## **Addendum #01**

CSD22-001 - S.G. Nesbitt Memorial Arena Concession Stand Supply and Renovation

PROJECT NAME	7 INDUSTRIAL AVE., CARLETON PLACE, ON - LAURYSSEN KITCHENS
PROJECT NO.	GWAL 2021-439
DATE	NOVEMBER 14, 2022
ADDENDUM NO.	M1

Drawing title/Titre du dessin  
**MECHANICAL PLUMBING  
NEW WORK REVISIONS**

**SK1**

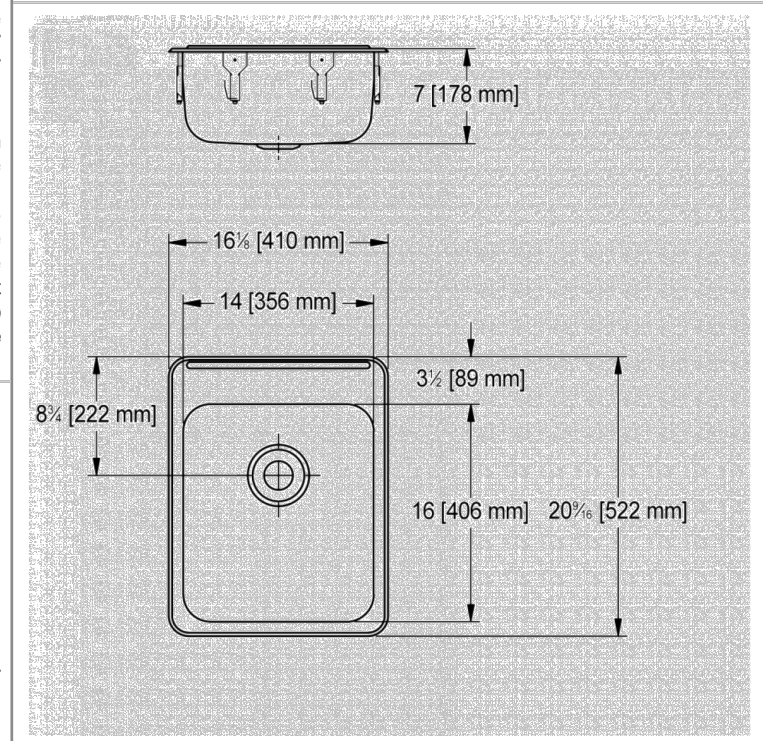
- 1.1 Mechanical contractor to provide and install sink SK1, refer to specification for sink detail. Coordinate with kitchen equipment and millwork.
- 1.2 Mechanical contractor to provide faucet (SK2) for triple sink provided by others. Coordinate faucet compatibility with triple compartment sink.

**SK2**

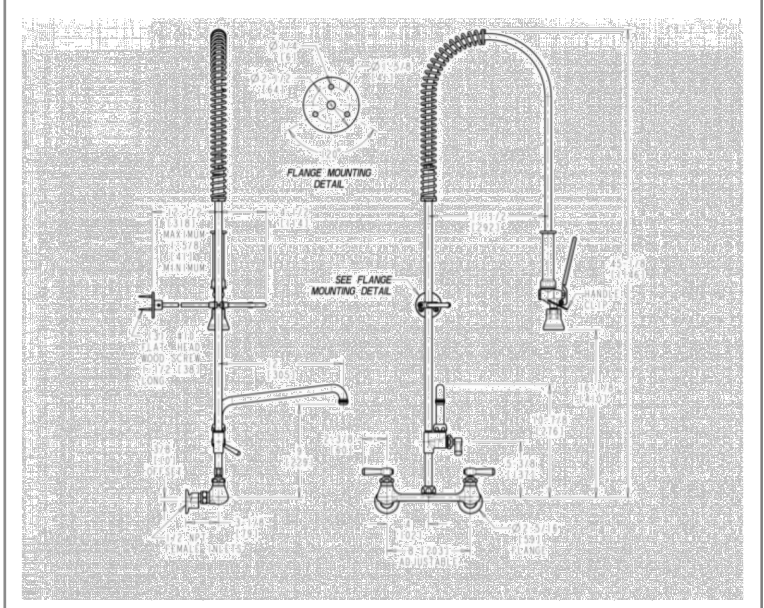
8. Point of sale equipment is not in contract. Will be provided by concessions stand operator.
  9. Refer to page 298 of Appendix J – Minden Hills Specs for manufacturer of triple compartment sink. Refer to Mechanical Addendum 1 drawing for manufacturer and model of faucet.

**ADD-M1-SK1**  
1

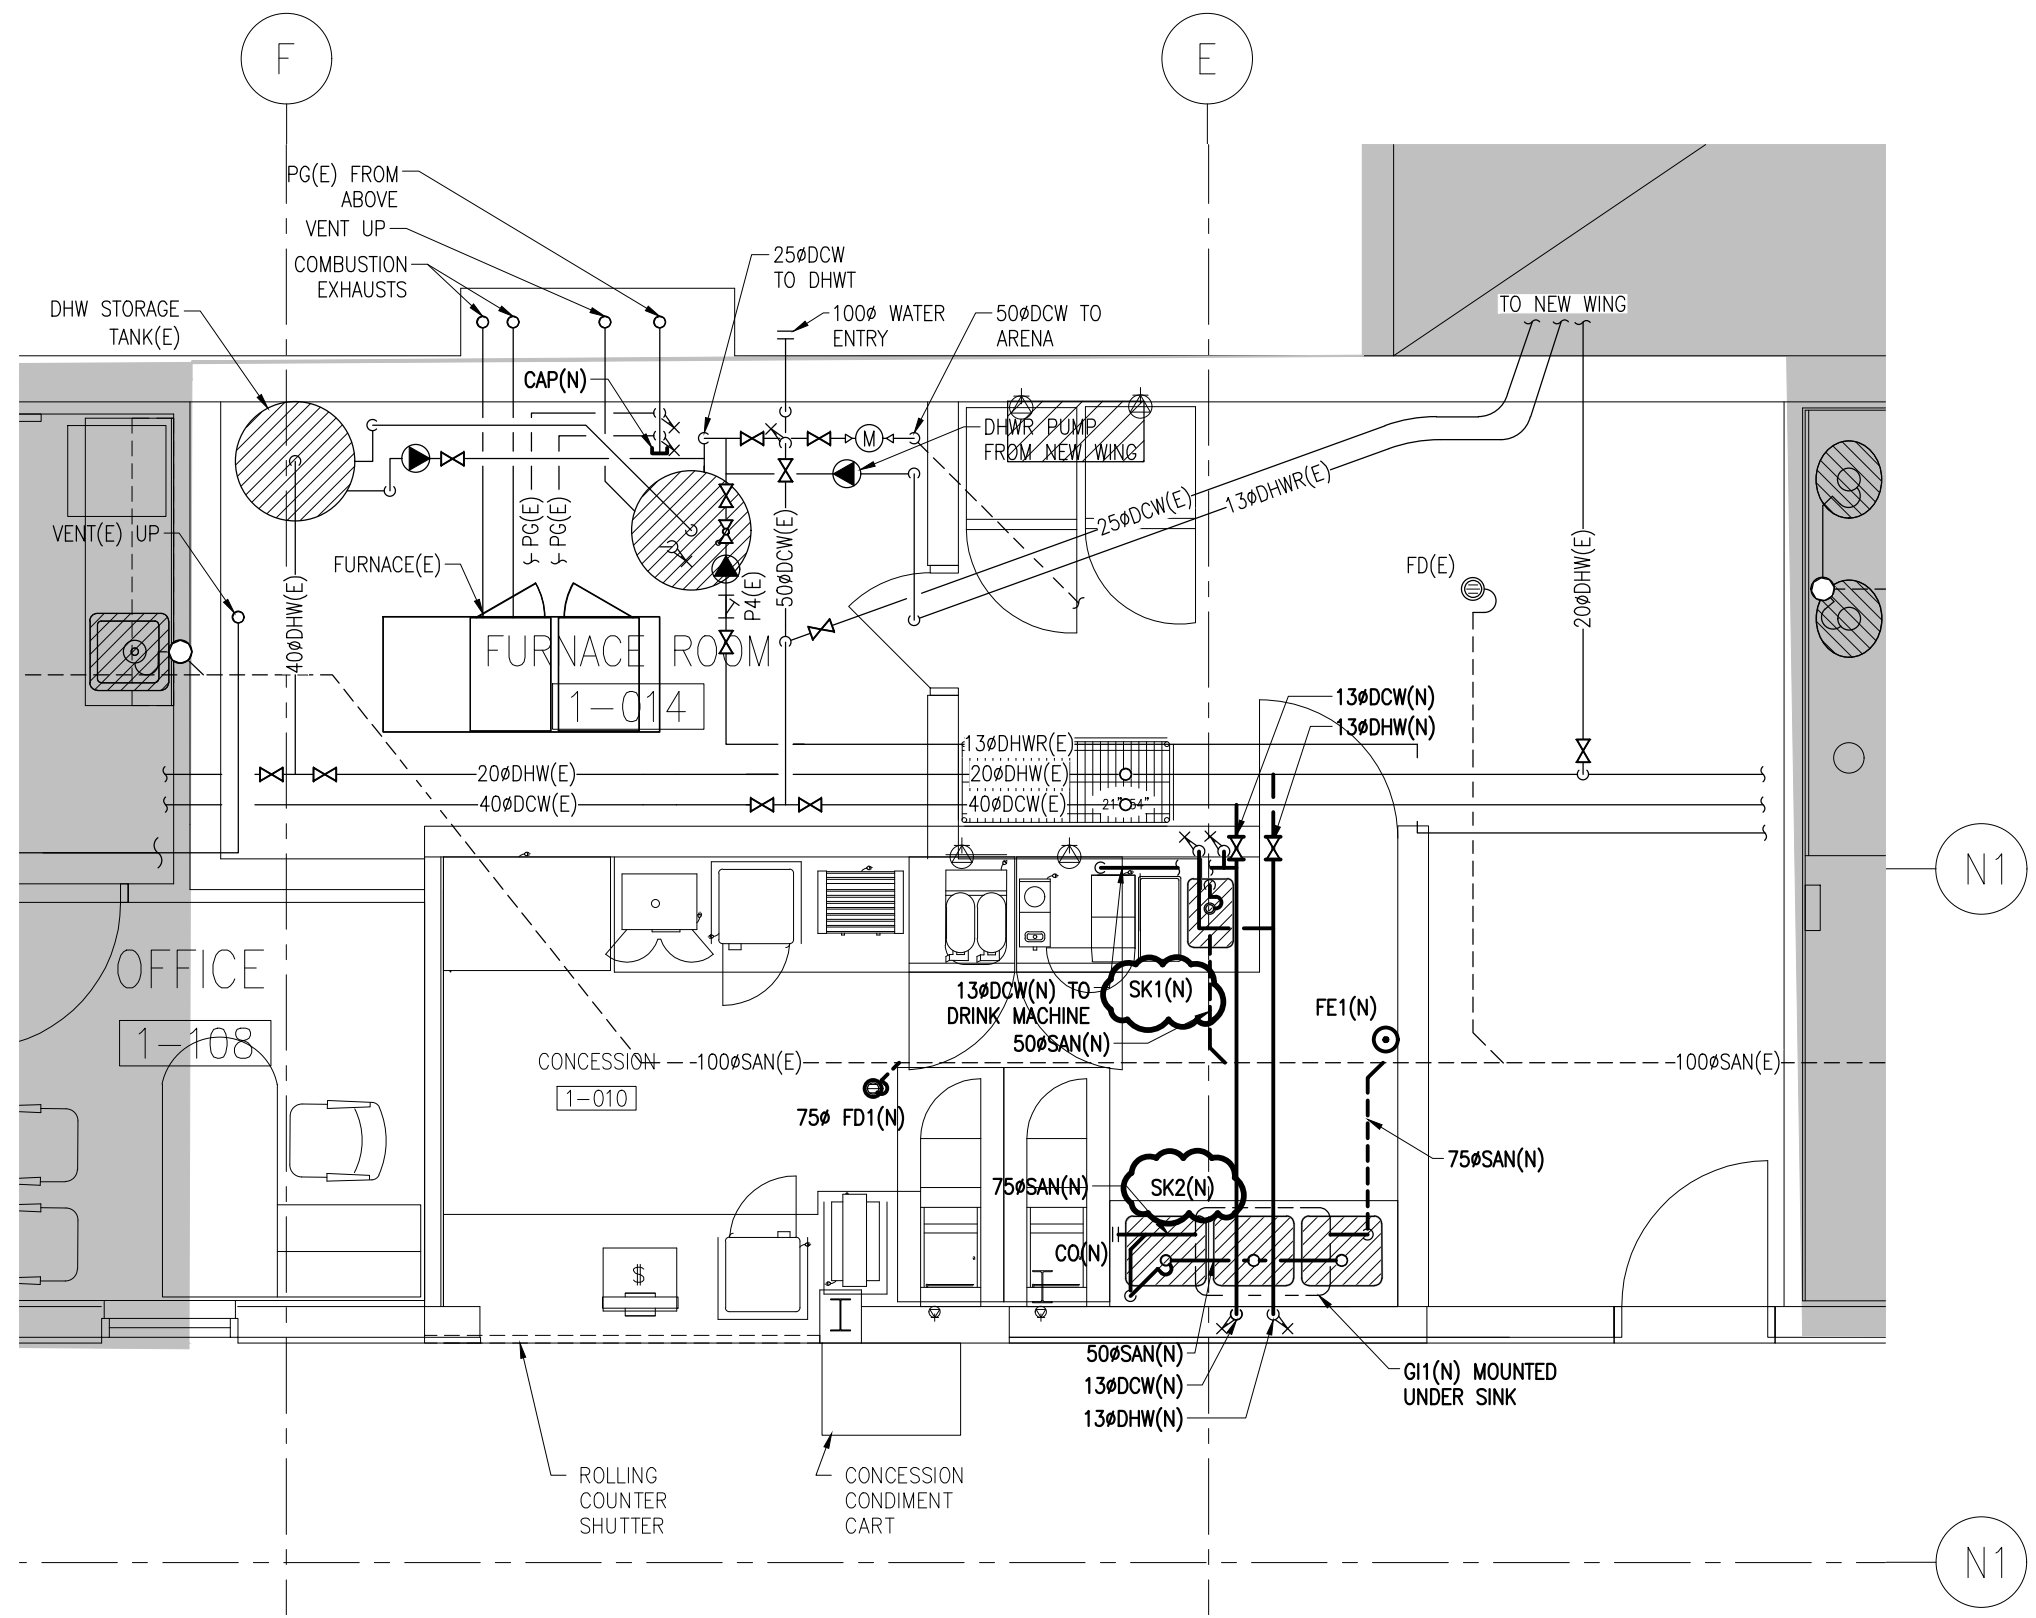
**1. Reference Drawings M1 and Attached Sketch ADD-M1-SK1:**
